SIGN PERMIT STAFF REPORT

Sign Review Commission

Site Address of Proposed Signage: 412 Main Street (parking lot next to Union Palace)

Proposed Sign Project: Replace existing freestanding sign (45 Square Feet) with new freestanding sign (44 Square Feet) in same location with no change in overall height

OLD SIGNAGE → NEW SIGNAGE

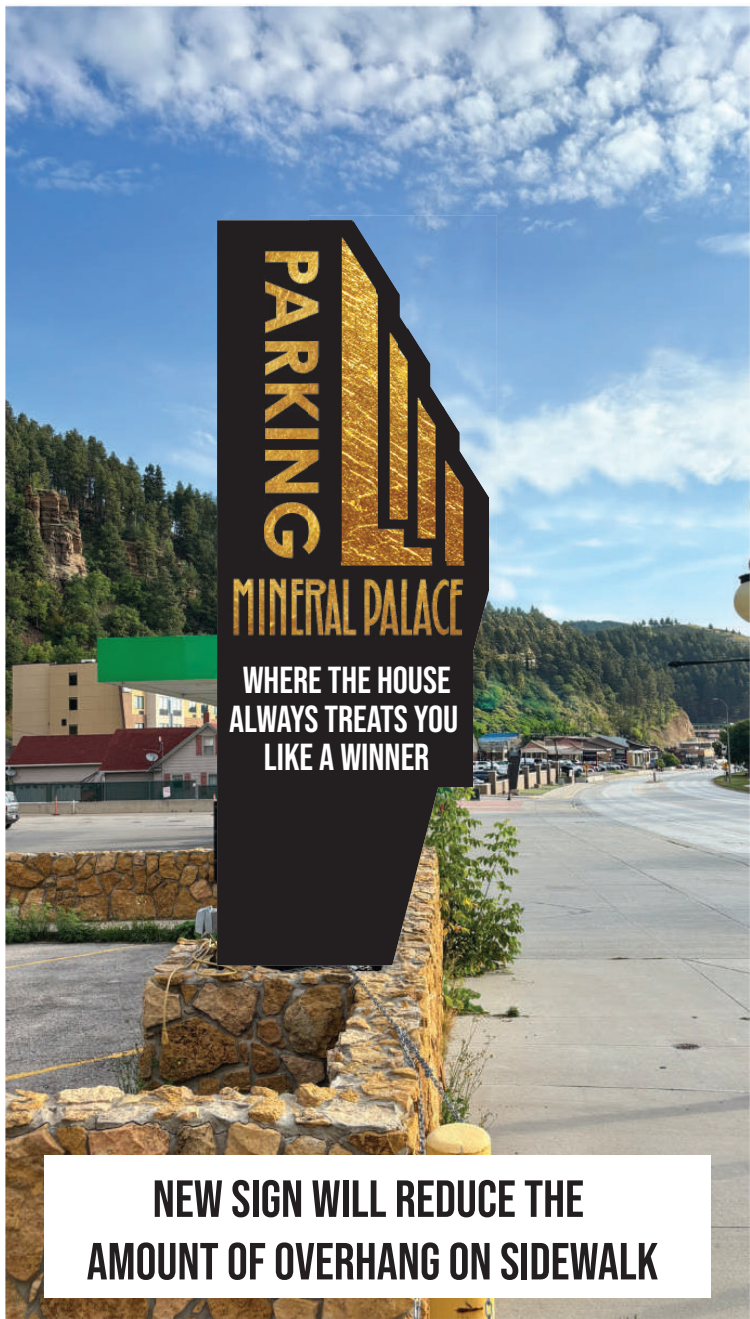
The applicant wishes to replace the existing freestanding sign with a new freestanding sign of a different design in the same location. The current sign was approved in 2007 on condition that it could not exceed 45 square feet and 15 feet in height. The 45 square feet was only the portion above the top of the mounting pole. The proposed sign's size of 44 square feet includes everything above the rock wall. The current sign also encroaches into the highway right of way, the proposed sign would not encroach.

The proposed sign and its location would remain compliant with the height and area conditions required by the City in 2007.
